July 30, 2010

**BELL BEND NUCLEAR POWER PLANT
IFIM AND AQUATIC IMPACT STUDIES
WORKPLAN UPDATE
BNP-2010-180 Docket No. 52-039**

Revision 2 of Section 6.3 of BNP-2010-103, "Study Plan to Assess the Potential Effects of the Bell Bend Project on Aquatic Resources and Downstream Users", dated April, 2010.

6.3. HABITAT REPRESENTATION AND TRANSECT SELECTION

Figure 6-4 The four major mesohabitat types in the aquatic habitat study reach

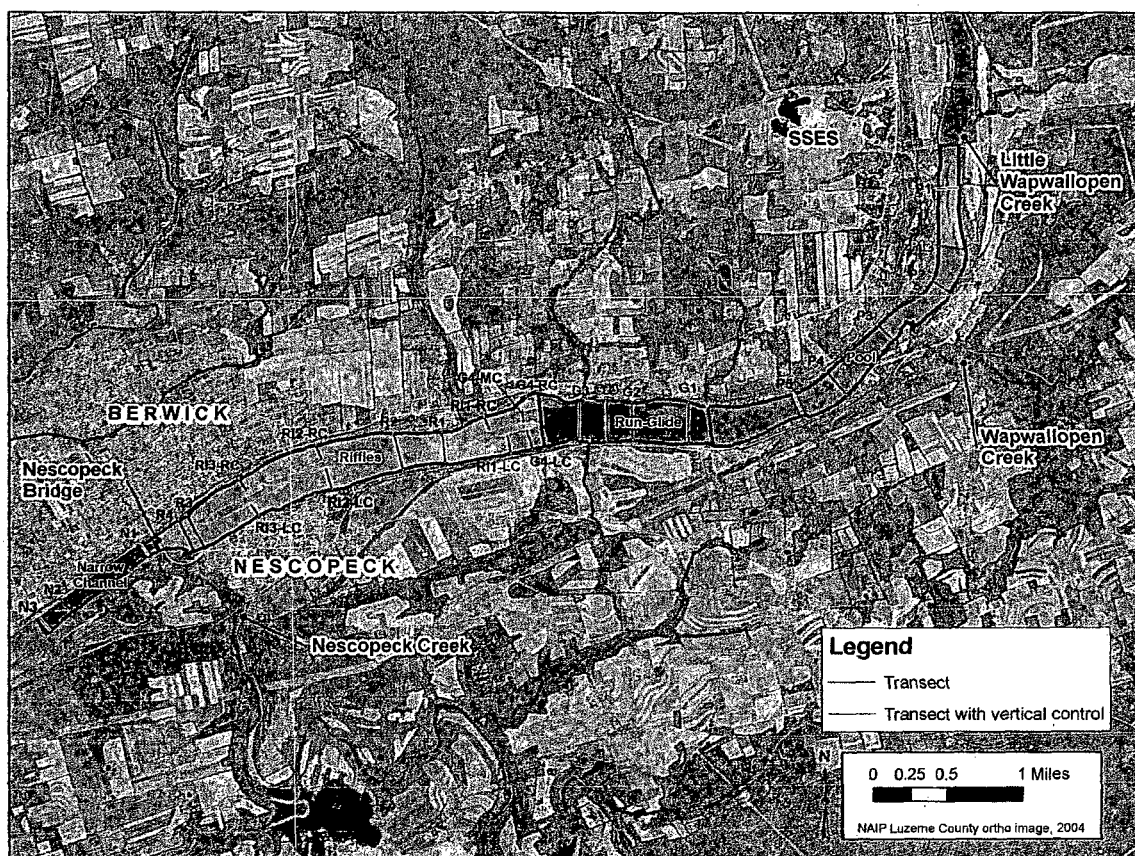
On July 21 a site visit by representatives of the SRBC, PFBC, and Anchor QEA (consultant to the SRBC) occurred. As a result of the low flow conditions present (about 2,000 cfs), portions of the river consisting of shallower bedrock shoal that could not be observed at the higher monitoring flows of 5,000 cfs and 10,000 cfs could now be seen. Specifically, one section between transects P1 and P2 was shallower and faster than the pool habitat upstream and downstream, and was characterized by abundant low bedrock ridges running nearly perpendicular to the direction of flow. In addition, the northern side of the river between Goose Island and Hess/Rocky islands also had similar bedrock ridges (here running nearly parallel to flow), features which were not incorporated into either transect G2 upstream or G3 downstream.

There were two transects added to the study as a result of the above observations made on July 21, 2010 jointly with the SRBC at low river flow:

The two added transects (P12 and G23) are shown in red.

- 1) An additional transect (P12) in the pool habitat between transects P1 and P2, shown in Figure 6-4.
- 2) An additional transect in the run/glide habitat between transects G2 and G3 (G23), also shown in Figure 6-4.

Field data including substrate, cover, depth and velocities will be collected at these new transects at the low target river flow of 2000 cfs. Conditions at other flows will be determined at these new transects by hydraulic modeling within the PHABSIM framework.
